Shakespeare Street / Cook Street Roundabout

Post Construction Safety Assessment

Project title	Shakespeare Street/Cook Street Roundabout
Document type	Post Construction Safety Assessment
Report number	2408021
Revision number	1

Figure 6: Kerb buildout constructed at the northwestern corner of the roundabout

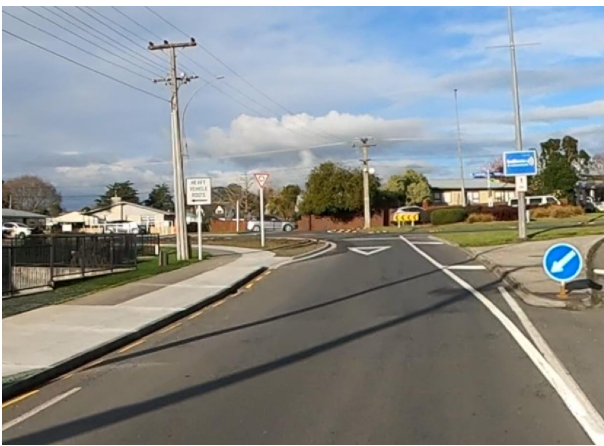
- Reduced circulating speed by all vehicles due to the improved horizontal deflections.
- Slower turning speeds for left turning vehicles from Cook Street due to the kerb buildouts.

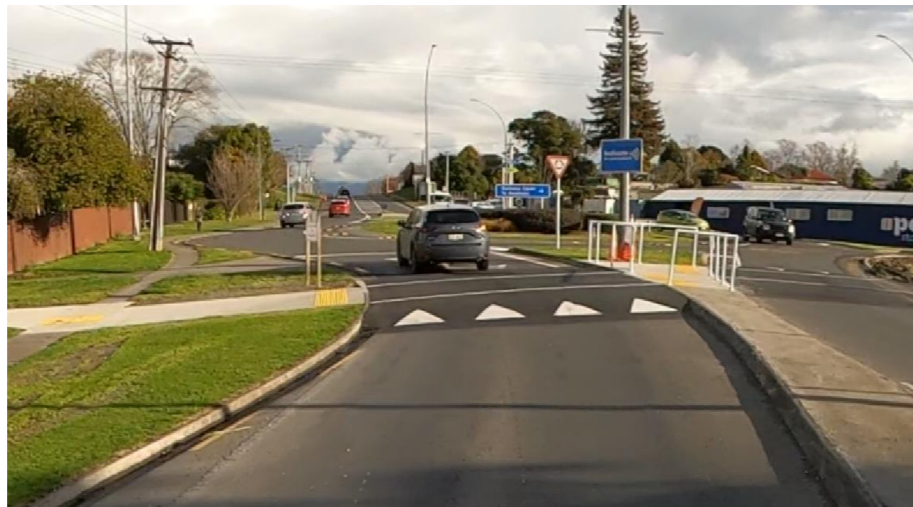
5.	Vehicle Operations	<p data-bbox="471 905 1412 1100">The kerb buildout was constructed at the northwestern corner of the roundabout to improve the vehicle approach angle closer to 90° as recommended by Austroads Guide to Road Design Part4B, which enhances driver’s visibilities and reduces turning speeds. However, it was observed that the approaching lane width on Cook Street has reduced substantially, which this may impact vehicular movement, and vehicles may mount onto the kerb buildout or traffic median island.</p>  <p data-bbox="471 1568 1175 1596">Figure 20: Narrowed Approaching Lane Width on Cook Street</p> <p data-bbox="471 1633 1412 1759">As discussed in Section 4.2, wheel tracks were observed at the northwestern corner during the site visit, and the reviewers were informed that they were caused by a house-moving truck in the wrong direction, which is not a typical user of the roundabout.</p>	Medium	<p data-bbox="1620 905 2493 1066">Consider preparing as-built drawings for the post-construction phase of the intersection and identify the largest vehicle that will be using this roundabout and carry out vehicle tracking on the vehicle type to ensure that the new intersection configuration can accommodate all types of vehicles expected to use this intersection.</p> <p data-bbox="1620 1110 2493 1209">If the movement of the largest vehicle that commonly uses the roundabout is restricted, consider realigning the kerblines to accommodate the vehicle's tracking</p> <p data-bbox="1620 1253 2510 1352">If the vehicle that caused the wheel track marks is not permitted to use this route, liaise with the over dimension permitting agency for help to enforce this restriction.</p>	Low	Low
